**CITY OF LEON VALLEY**  
**PLANNING & ZONING COMMISSION**  
Leon Valley City Council Chambers  
6400 El Verde Road, Leon Valley, TX 78238  
Tuesday, February 25, 2025 at 6:30 PM

**SUBJECT:** Presentation and Discussion, to Gain Preliminary Feedback From the Planning and Zoning Commission for a request to Amend Ordinance 2021-54 PD Planned Development District, with B-3 Commercial District and No SO, Sustainability Zoning to PD Planned Development District with R-3 Multiple-Family Dwelling District on Approximately 2.85 Acres at 6758 Poss Road; More Specifically Described at CB 5784, Block 4, Lot 64, Quality Subdivision.

**SUBJECT:** Presentation and Discussion to Gain Preliminary Feedback From the Planning and Zoning Commission on a Request for a Zone Change from R-1 Single-Family Dwelling District to Planned Development District (PDD), with R-4 Townhouse District Base Zoning District on Approximately 6.8 Acres of Land at 6612 and 6618 Sawyer Road; and More Specifically Described as the Southwest 400 Feet of Lot 3, and the Northwest 330.13 Feet of Lots 10, 11, 12, and 13, and the Northeast 20 Feet of Lot 10, CB 5784, Leon Valley Addition Subdivision

# Site Plan – Concept #1

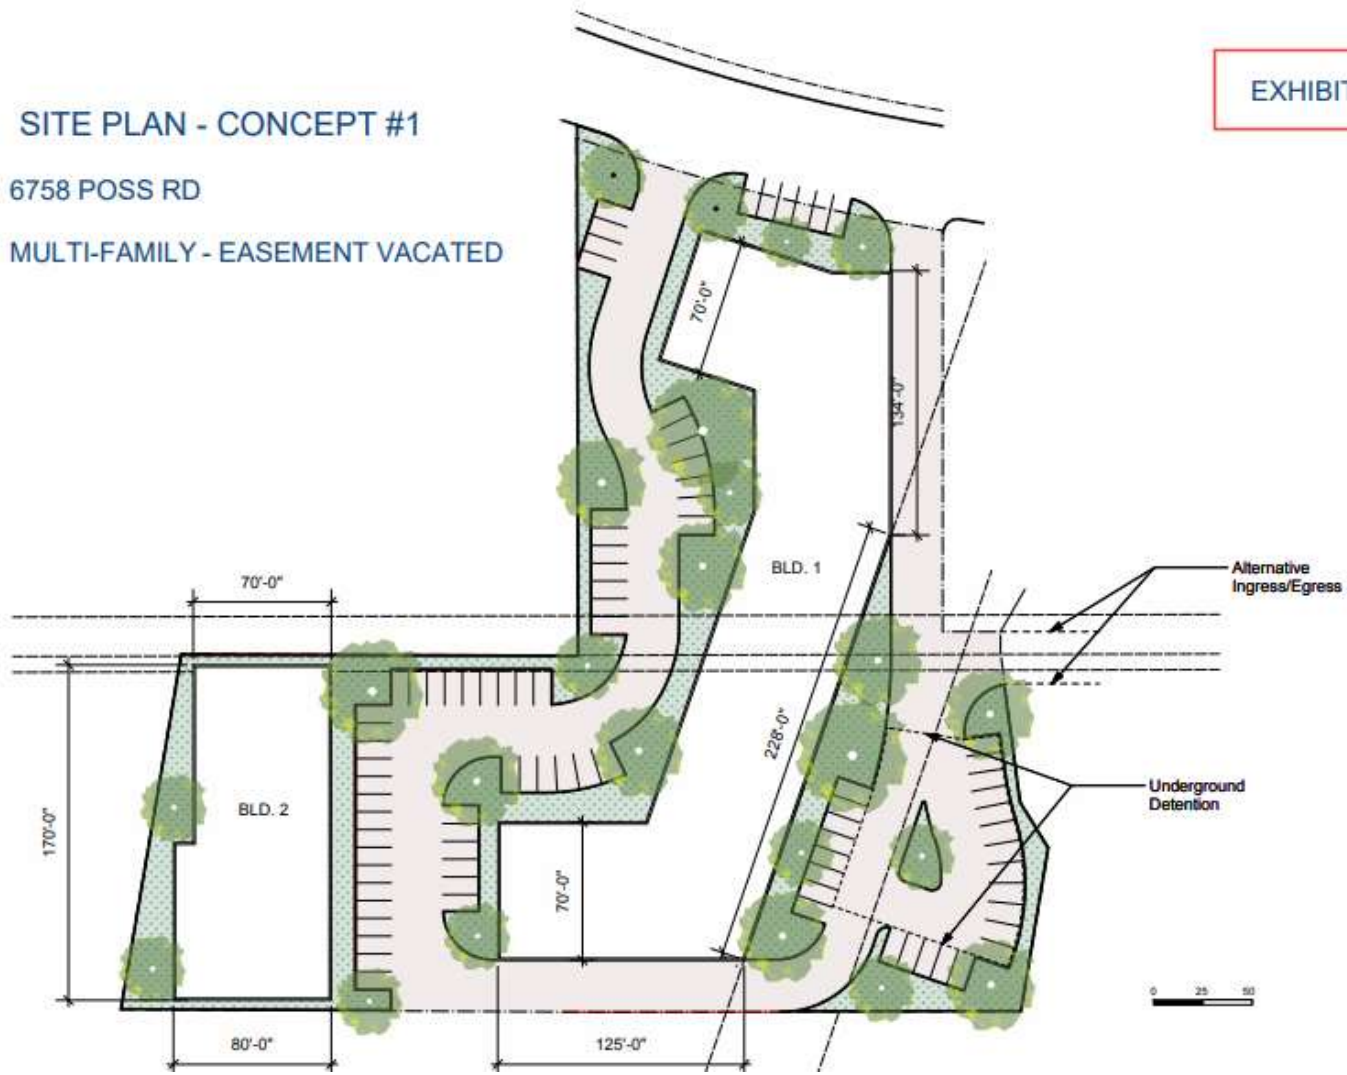
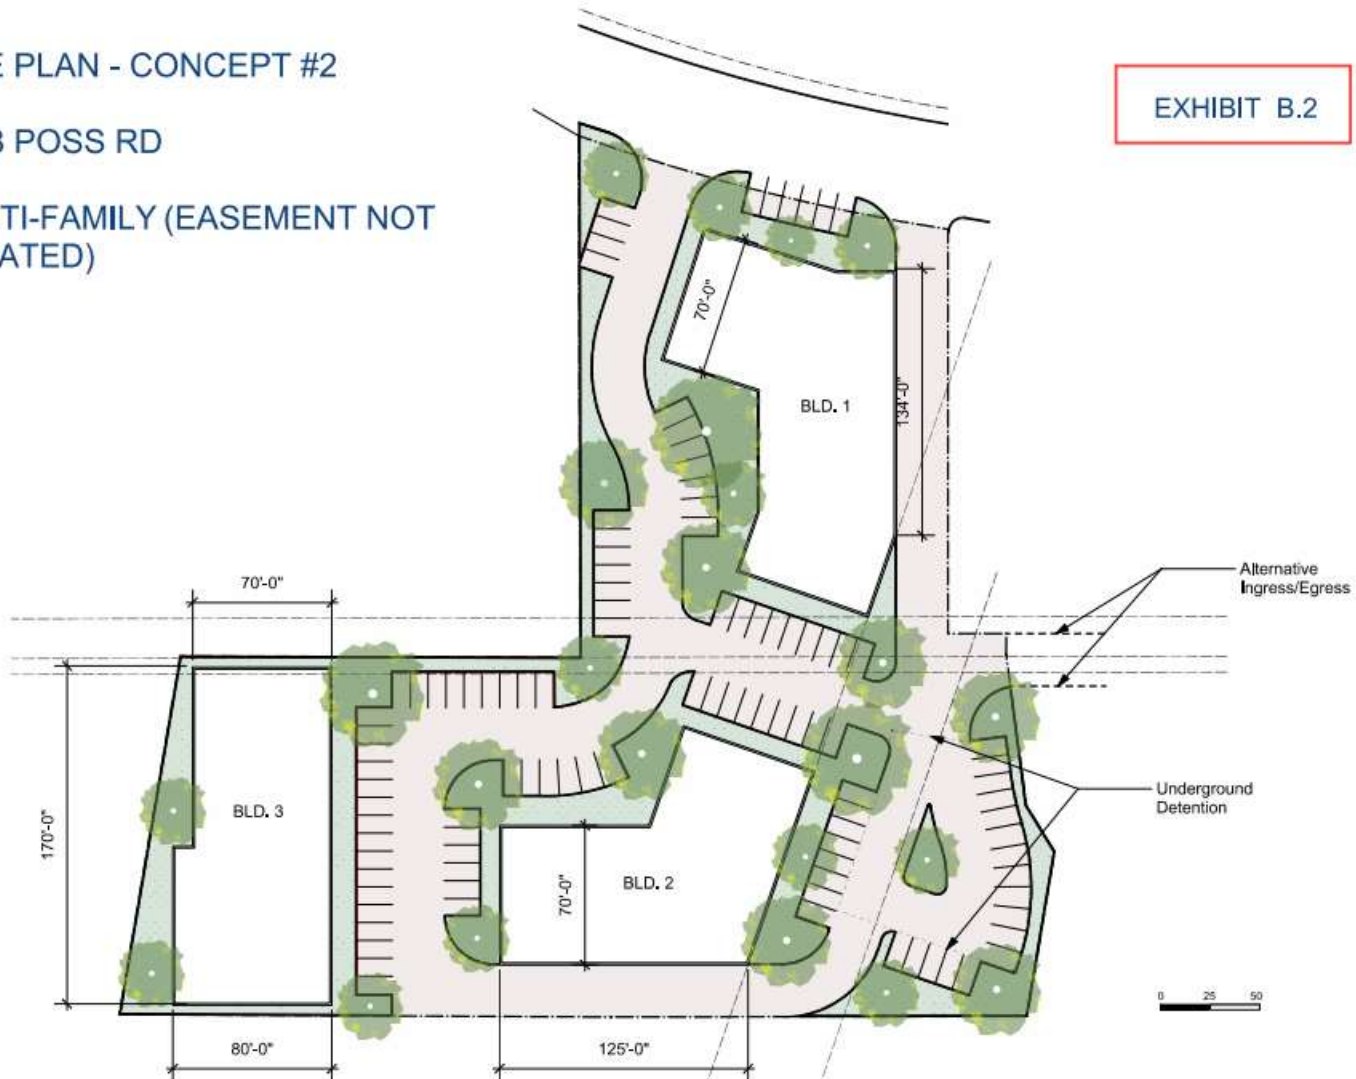
- Staff recommends approval of either option for the amended PDD
  - Both consistent & compatible with the City's Master Plan & surrounding uses
  - Would make good use of a property that has physical developmental conflicts
    - Odd shape, difficult easements, & low visibility for retail or commercial use
  - Staff has no objection to proposed variances for lot requirements, with exception of parking requirements, if the development is for general occupancy apartments.

# EXHIBIT B

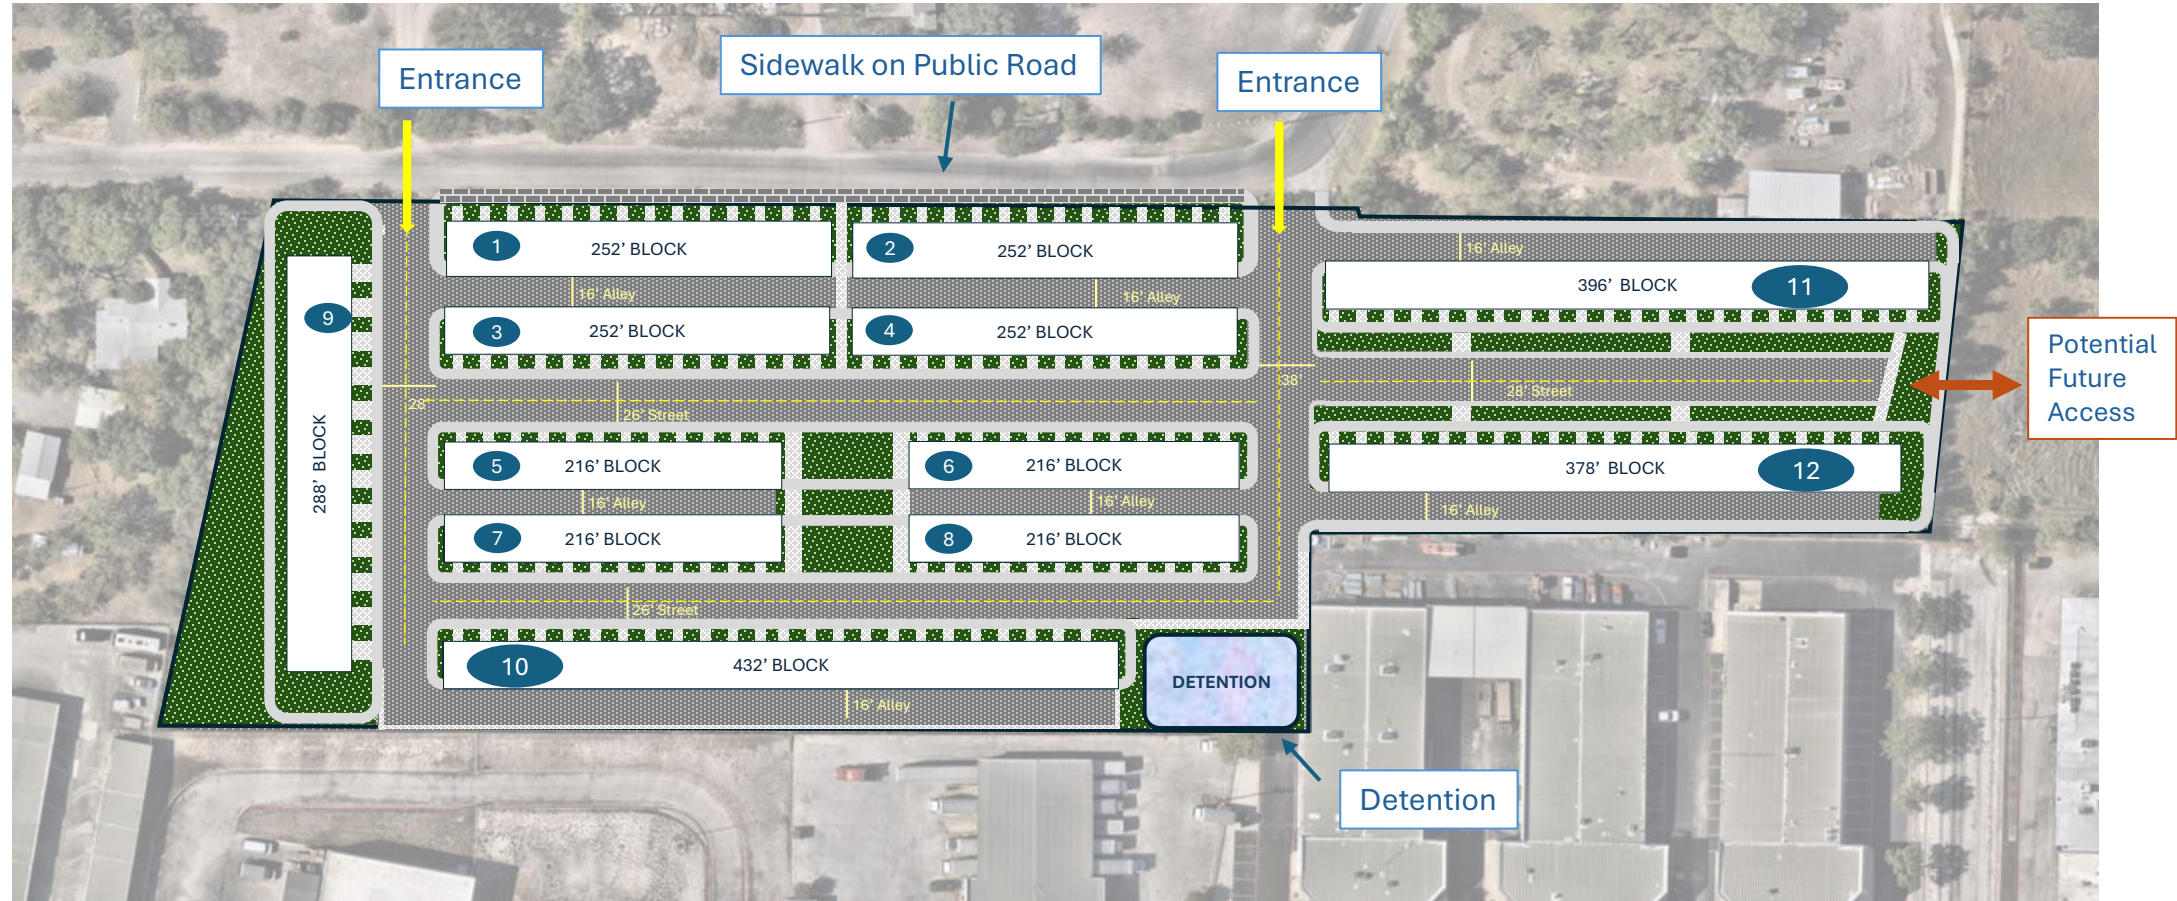
The issue of the proposed Base Zoning District needs to be resolved before staff can comment further on the requested variances. This property will need to be replatted prior to any development or construction.

Staff recommends the applicant revise the application to reflect a base zoning district of R-3 Multiple-Family Dwelling District, with revised variance requests and that, if the revised request is approved, the Planning and Zoning Commission require the property owner to provide legal documentation of a condominium association.
